## SERVICE BULLETIN

DATE: 3/10/53  
Revised 6/1/55

B-91  
NO.

### MAGNAFLUX ACCEPTANCE STANDARD FOR CONNECTING RODS FOR THE SUBJECT 6A4-150, 6A4-165, 6V4-178 AND 6V4-200 ENGINES

SKETCH 1

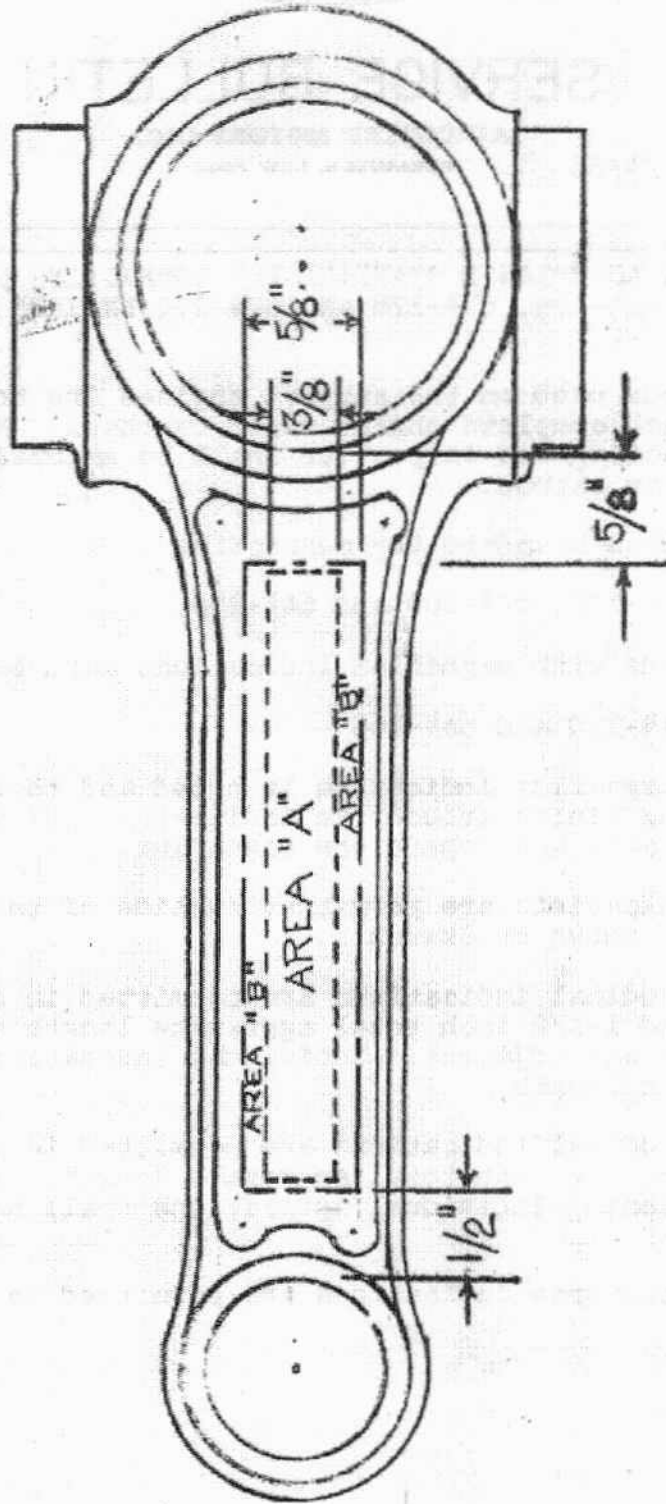
2) No indications are permitted outside of the rectangular zones A and B, as shown on Sketch I.

3) Longitudinal indications are permitted in area A, provided they do not exceed 1-1/2 inch total aggregate length and are not connected and are not adjacent. Individual indications shall not exceed 3/4 inch in length.

4) Longitudinal indications are permitted in area B, provided they do not exceed 1/2 inch total aggregate length, are not connected, and are not adjacent. Individual indications shall not exceed 1/4 inch in length.

5) No transverse indications are permitted in any area.
